MEETING NOTICE

PLAN COMMISSION

TOWN OF BROOKFIELD PLAN COMMISSION ZONING REPORT

RE: **Oscar's Frozen Custard – Conditional Use Permit
21165 Hwy 18 BKFT1130999001 & 1128959001**

SHEET NUMBER
C200

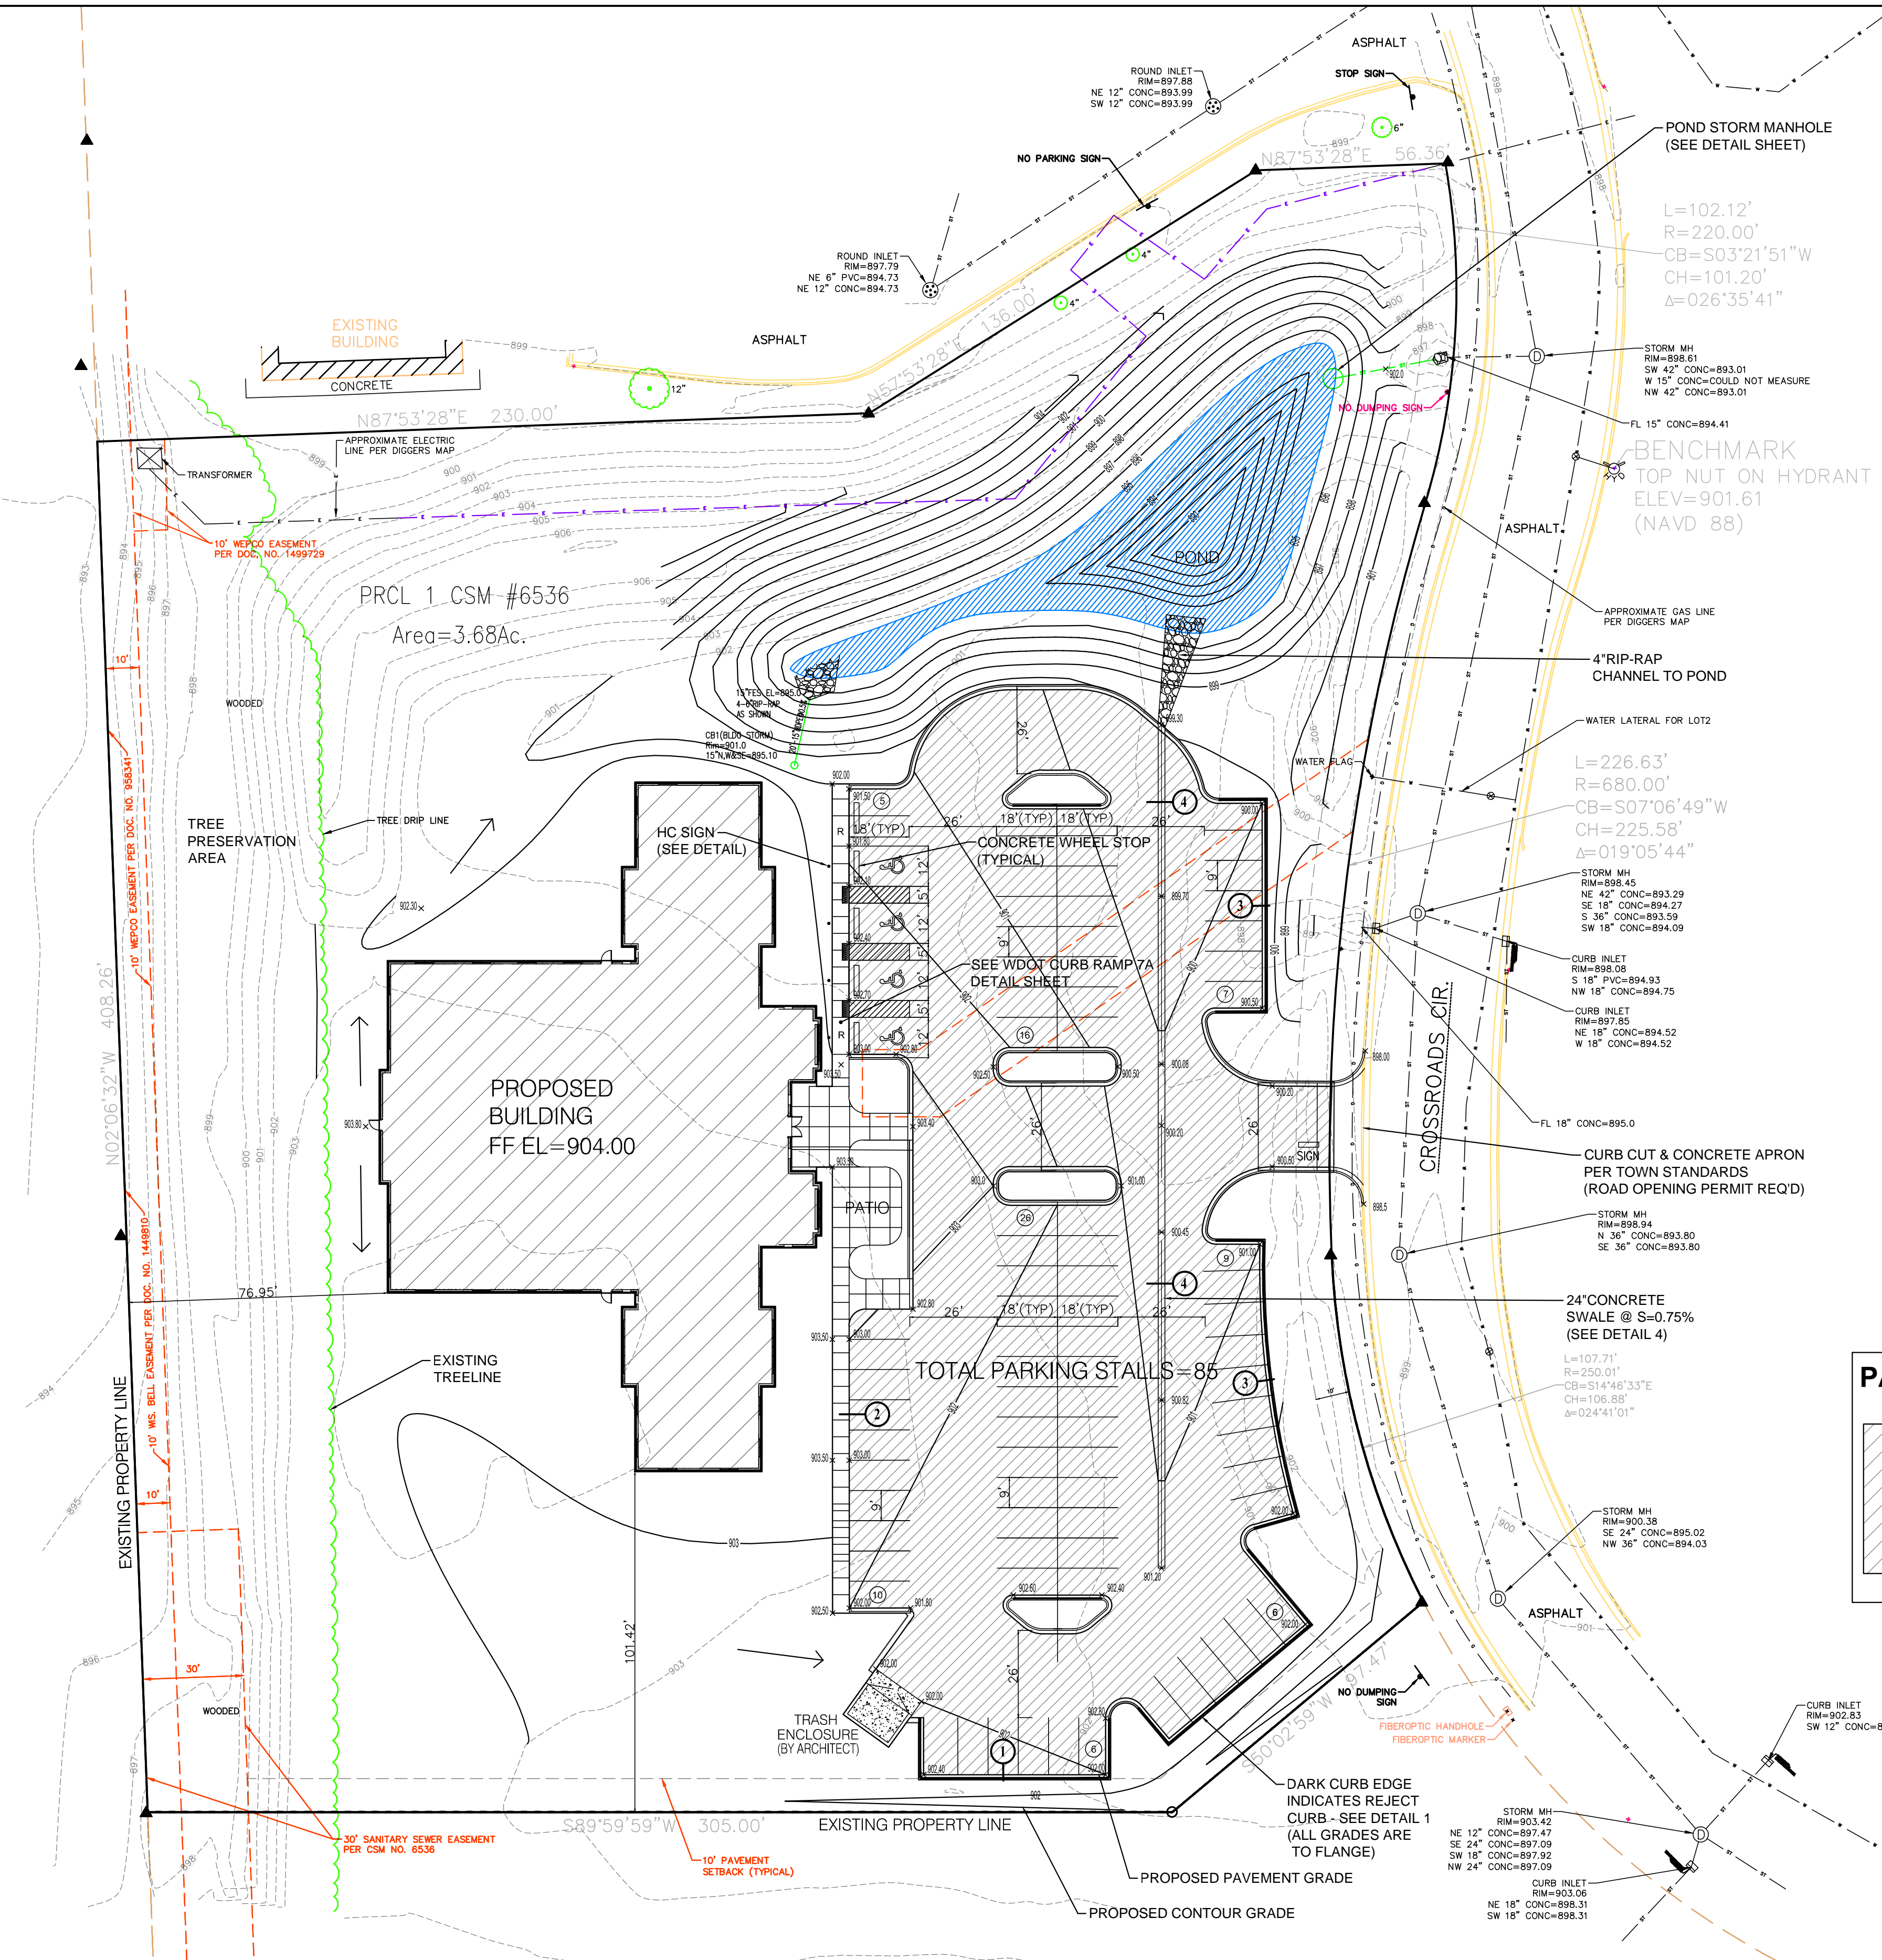
- According to our records the existing water service in Crossroads Cir is 6", they are proposing connecting a 8" watermain to it. So the existing service will need to be abandoned and tap a new 8" tee and valve or the existing 8"x6" Tee be replaced by a 8"x8" Tee. Either way the watermain will need to be turned off to abandon the existing 6", the neighboring office buildings will need to be notified and this may need to be completed at night. The existing watermain is in the street so street restoration and traffic control should be added.

- The proposed 8" watermain and hydrant will become public, it should be noted and I believe a DNR approval will be needed.
- The "Hydrant Installation Figure 2" specifies a Ductile Iron Lead, we allow PVC.
